PRODUCT CHANGE NOTIFICATION

#PCN-IFC-9H6R-16

Business Unit	Product Line Code	Type of Change	Action	Date of issue
IFC	BF2	Mechanical	Notify Distributors and Field	2/15/2016

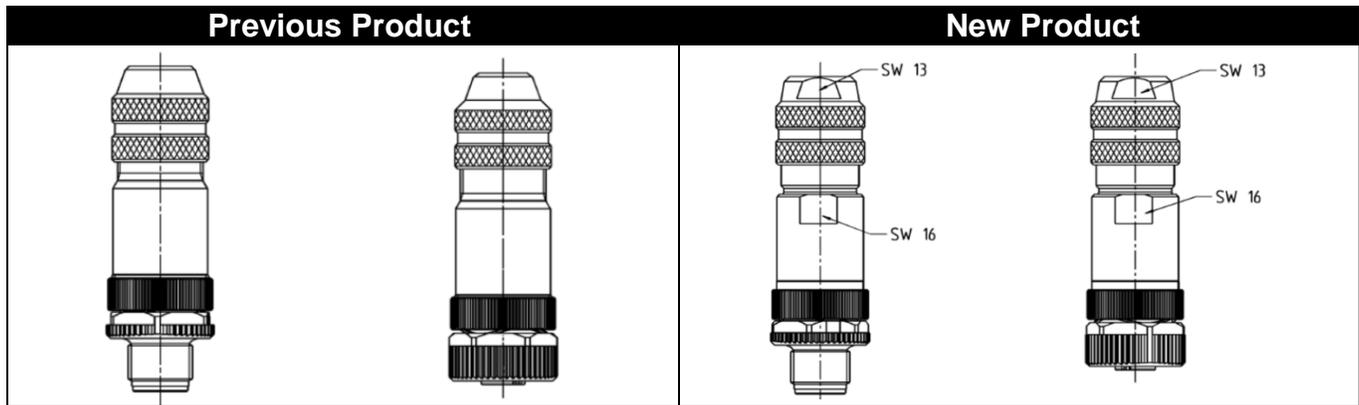
The metal housing for the attached list of M12 connectors will now include flats for standard wrenches to aid in connector assembly. An SW 13 flat will be added to the rear locknut of all connectors. An SW 16 flat will be added to the main connector body of all straight connectors.
